Aircraft Design Certification GmbH Reichensteinstr.48 69151 Neckargemünd		Bristell B23 - Exhaust retrofit	Doc-Nr: ADxC-73-SB-044 Issue: A Date: 14.05.2024 Change-no.: ADxC-73-DC-110
Service Bulletin

<p>Bristell B23 - Exhaust retrofit</p> <p>Optional retrofit of exhaust system with higher diameter tubing (DC-110). , Optional retrofit of exhaust system and silencer with higher diameter tubing (DC-115) with corresponding changes to the DC-110 exhaust system and front fuselage. Subsequent furnishing of AFM and AMM supplements. Version without silencer (DC-110) and with silencer (DC-115) both described in this bulletin.</p> <p>Reduction of Exhaust back pressure</p>

Optional retrofit of B23 exhaust system with the following equipment according ADxC-DC-73-110:

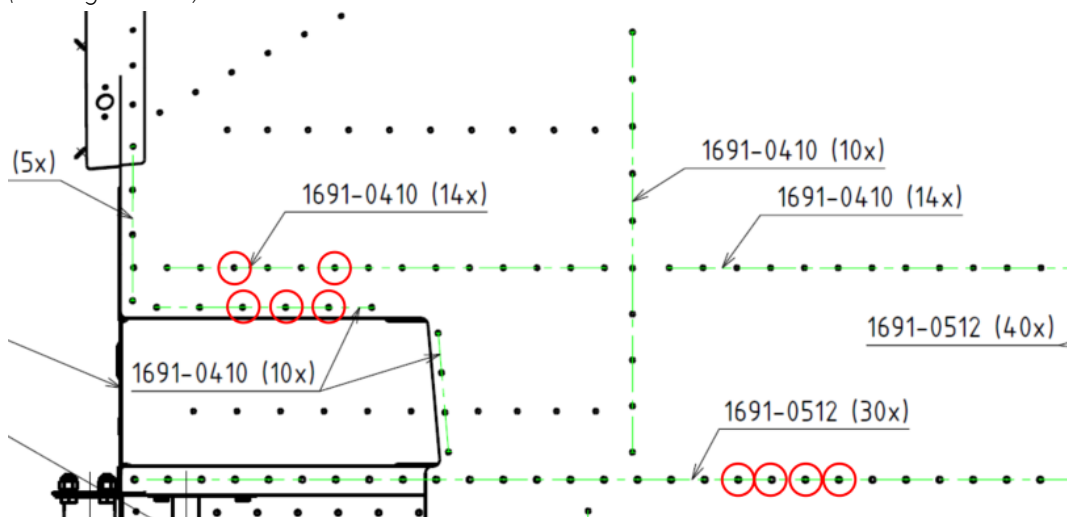
- 1) Remove silencer (if installed). For instructions refer to chapter 78-20 of the DC-012 maintenance manual (ADxC-73-012-AMM, , ref. 1.11).
Remove the complete original type design exhaust system (71B24000N). For instructions refer to chapter 78-00 of the main maintenance manual (ADxC-73-001-AMM, ref. 1.11).
- 2) *Unrivet rivets 19-22 counting from the first rivet on the firewall in the row left of the Nose Landing Gear bay and on the over next row rivets 4-6, as well as the rivets 4 and 7 in the adjacent row (leaving out 5&6):*

- 3) *Install the supplied brackets oriented as depicted on the installation drawing.*
- 4) *Relocate electric connector and drain hoses as defined on drawing 71B240135N.*
- 5) Install the supplied exhaust/silencer assembly 71B241100N (according to drawing 71B241000N and its supplement 71B241100N)
Mount the clamps on the main silencer body (front and rear) to the shock absorber bracket (sandwiching of the shock absorber metal sheet: *clamp – shock absorber – clamp*) by use of the defined washers, bolts and nuts. Just tighten the bolt-connection so that the clamp is still movable in axial and radial direction.

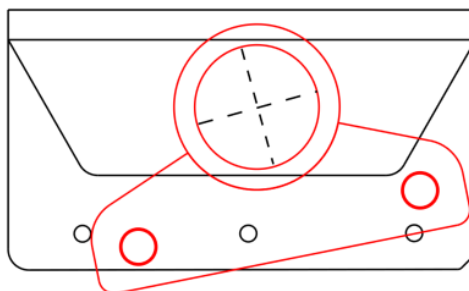
- 6) Connect the main body of the silencer to the flexible hose using the supplied springs.
- 7) Position the silencer main body and clamps, so that the middle point of the bushing of both shock absorber brackets is the most possible in the middle of the fuselage brackets:

Mark the middle point of the bushing on each bracket. Drill an 8mm hole at the marked position into each bracket and smooth the edges.
